TECHNICAL BULLETIN

DUAL ESSENTIAL BUS RELAYS MODIFICATION

* Supersedes Technical Bulletin 900-0018R1, dated 30 December 1999. Revised to correct the existing wiring in Figure 2 and to notify operators that the IFR procedures mentioned in paragraph 1.C. have been revised. Aircraft that complied with previous versions of TB900-018, meet the intent of this revision.

MD-900 (902 Configuration) helicopters, serial number 0052 thru 0068 and 0070.

Figure 1. External Power Box Assembly Modification

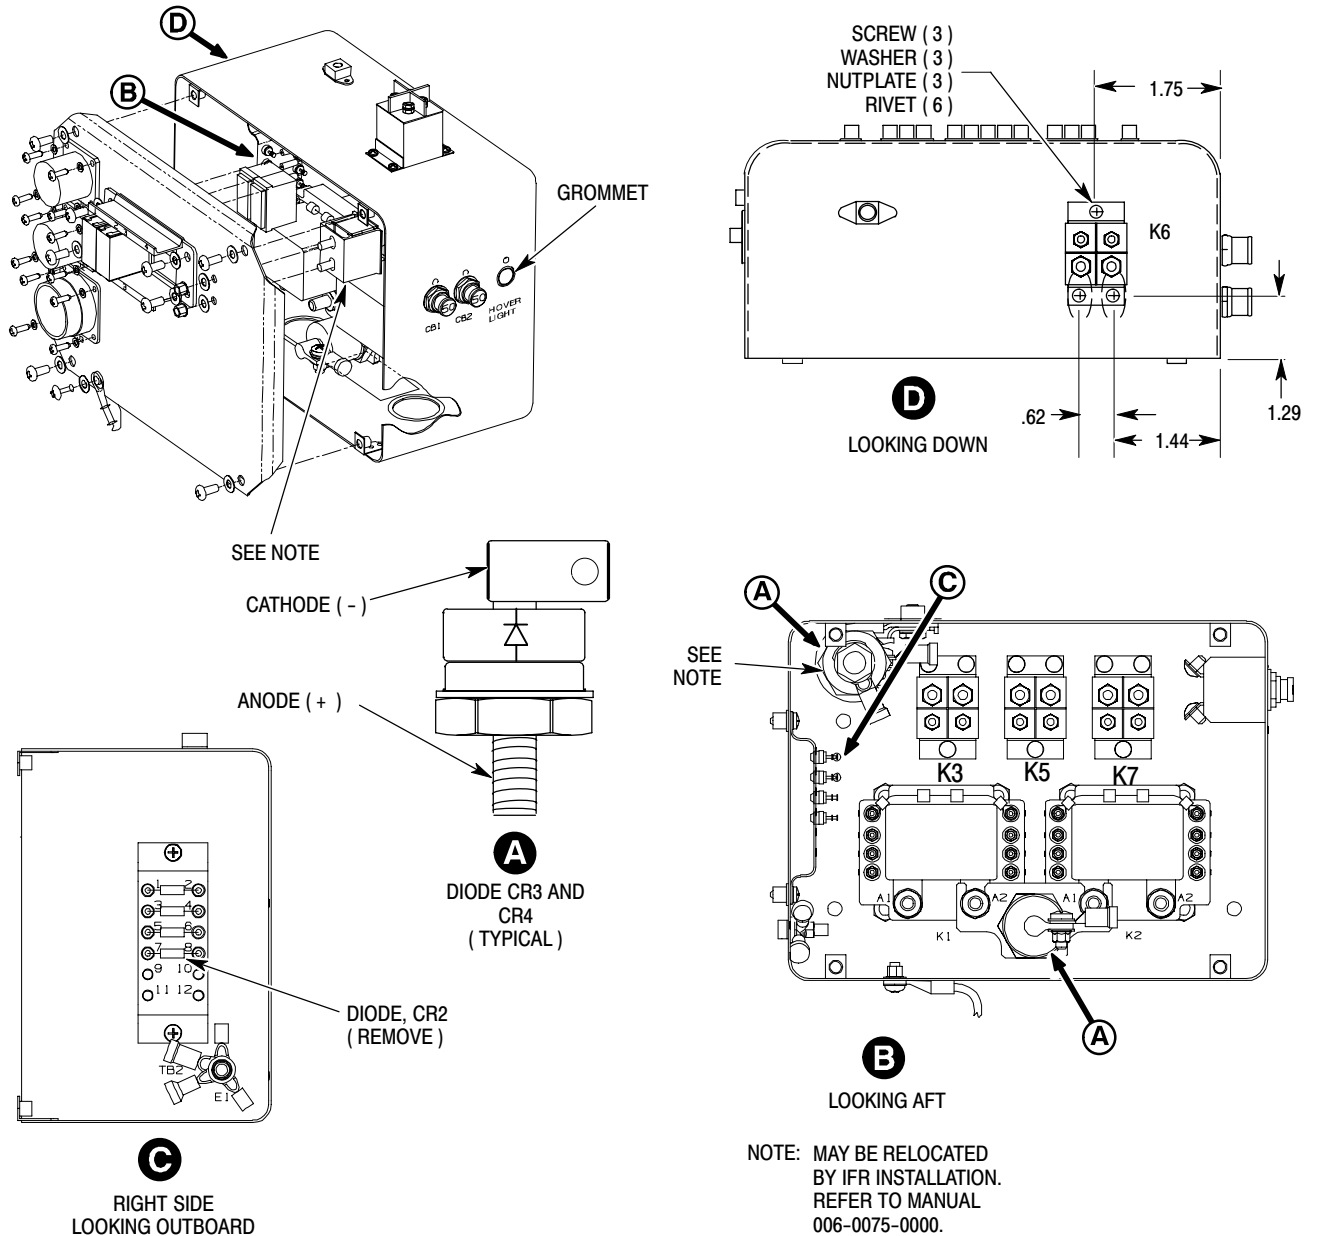
- (1). Open A610 External Power Box Assembly (Ref. Section 96-30-00 of CSP-900RMM-3).
- (2). Remove jumper wire P30C10 EMI 3 or alternate HS4836-284302 bus bar between CB1 and CB2.

- (19). Remove wire L12C20 EMI 3 from K6-A1 to J2-F.
- (20). Relocate relay, K6, and install new relay, K7.
 - (a). Remove and retain existing relay, K6, and mounting hardware.

- (b). Locate three each relay mounting holes on top of external power box assembly.
 - (c). Drill three each 0.209 inch (5.31 mm) relay mounting holes with a #4 drill and deburr.

- (d). Locate six each nut plate attach holes on top of external power box assembly (orientation of the nutplates is optional).
 - (e). Drill six each 0.096 inch (2.38 mm) nut plate attach holes with a #40 drill and deburr.

- (f). Install three each MS1059L06 nutplates with six each NAS1097AD3 rivets.

- (g). Reinstall relay removed in step (a) on top of external power box assembly with three each NAS601-6P screws and NAS620-6L washers.
 - (h). Install KM-U5NL-014 (or alternate) relay, K7, in position where relay, K6, was removed using hardware retained in step (a).

- (i). Change K6 label to K7 and label relocated relay, K6, on top of external power box assembly using permanent ink.
- (21). If installed, remove plug from hole labeled CB3 on side of external power box assembly.

- (22). Install MS35489-6X grommet in hole on side of external power box assembly using EA9330-3 epoxy adhesive per manufacturer's instructions.
 - (23). Change "CB3" label below grommet to "HOVER LIGHT" using permanent ink

Figure 2. External Power Box Assembly Wiring Diagram (Sheet 1 of 2)

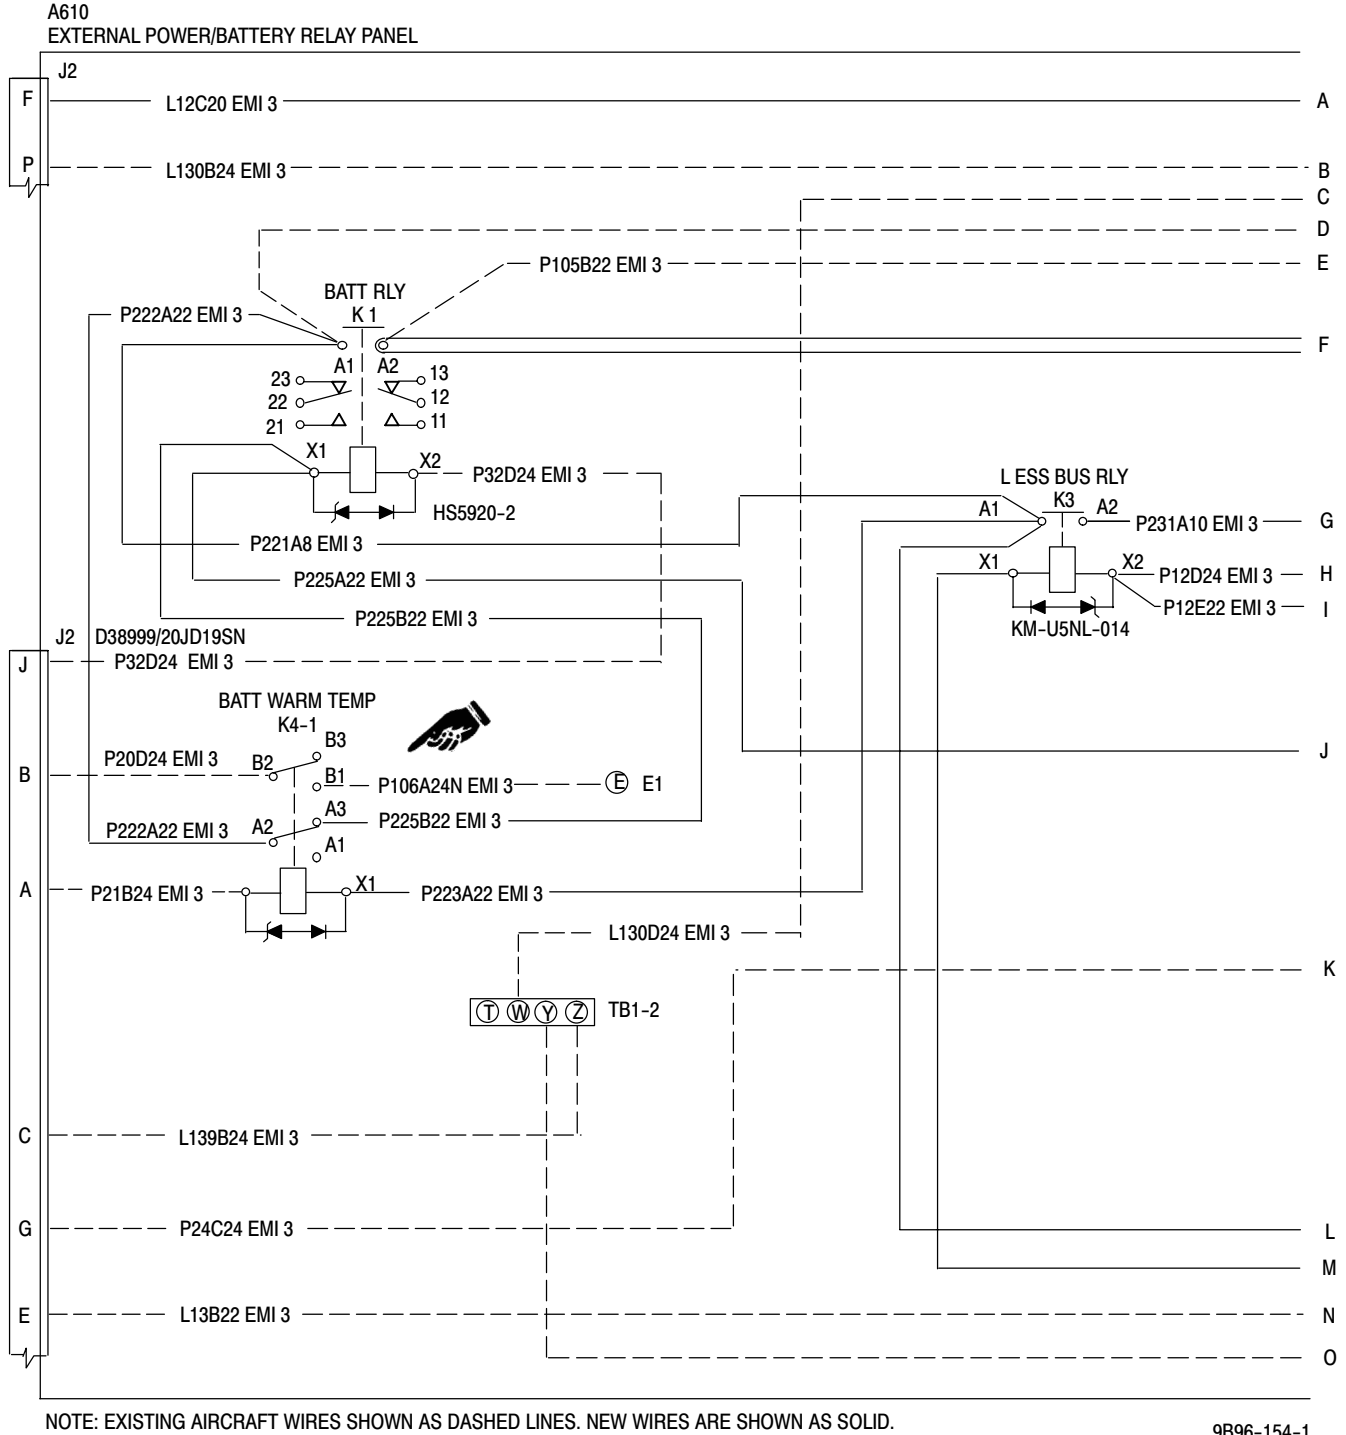
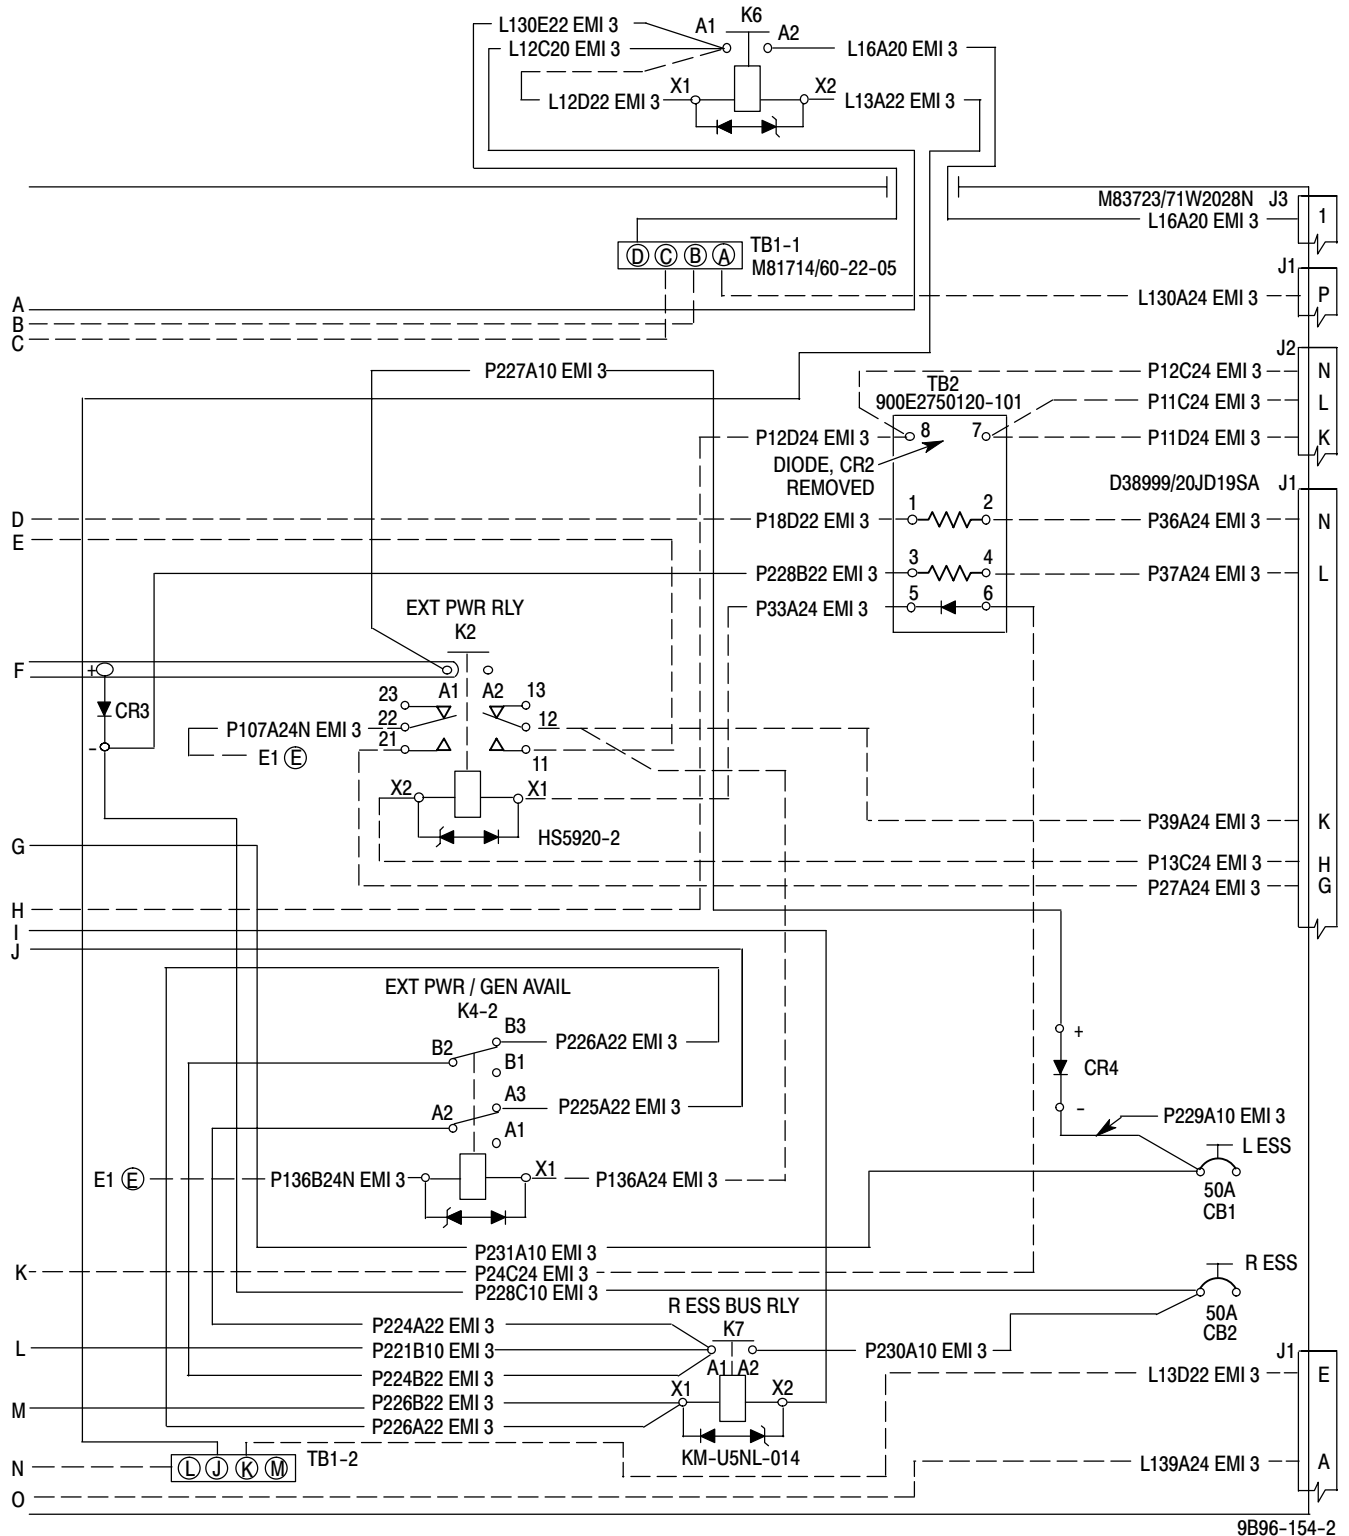
- (26). Install new wire L12C20 EMI 3 from K6-A1 to J2-F (Ref. Figure 2).
 - (27). Install new wire L130E22 EMI 3 from K6-A1 to TB1-1-D.
 - (28). Install new wire L13A22 EMI 3 from K6-X2 to TB1-2-J.

- (31). Install new wire P222A22 EMI 3 from K1-A1 to K4-1-A2.
 - (32). Install new wire P221A8 EMI 3 from K1-A1 to K3-A1.
 - (33). Install new wire P225A22 EMI 3 from K1-X1 to K4-2-A3.

- (34). Install new wire P225B22 EMI 3 from K1-X1 to K4-1-A3.
 - (35). Install new wire P223A22 EMI 3 from K4-1-X1 to K3-A1.
 - (36). Install new wire P221B10 EMI 3 from K3-A1 to K7-A1.

- (37). Install new wire P226B22 EMI 3 from K3-X1 to K7-X1.
 - (38). Install new wire P12E22 EMI 3 from K3-X2 to K7-X2.
 - (39). Install new wire P231A10 EMI 3 from K3-A2 to CB1 (LINE).

- (40). Install new wire P224B22 EMI 3 from K4-2-B2 to K7-A1.
 - (41). Install new wire P224A22 EMI 3 from K4-2-A2 to K7-A1.
 - (42). Install new wire P226A22 EMI 3 from K4-2-B3 to K7-X1.

- (43). Install new wire P230A10 EMI 3 from K7-A2 to CB2 (LINE).

- (44). Install new wire P227A10 EMI 3 from K2-A1 to CR4 (+).
- (45). Install new wire P229A10 EMI 3 from CR4 (-) to CB1 (LINE).
- (46). Install new wire P228B22 EMI 3 from CR3 (-) to TB2-3.
- (47). Install new wire P228C10 EMI 3 from CR3 (-) to CB2 (LINE).
- (48). Check wiring in modified external power box assembly as follows:
 - (a). Check for open circuit (>1 megohm) from CB1 (LINE) to CB2 (LINE).
 - (b). Check for open circuit (>1 megohm) from CB2 (LINE) to CB1 (LINE).
 - (c). If open circuit is not indicated in steps (a) and (b) above, check polarity of diode, CR4, and associated wiring.
- (49). Ink stamp with permanent ink **MODIFIED BY TB900-018R1** next to the part number on external power box assembly.
- (50). Close and install the A610 external power box assembly (Ref. Section 96-30-00 of CSP-900RMM-3).
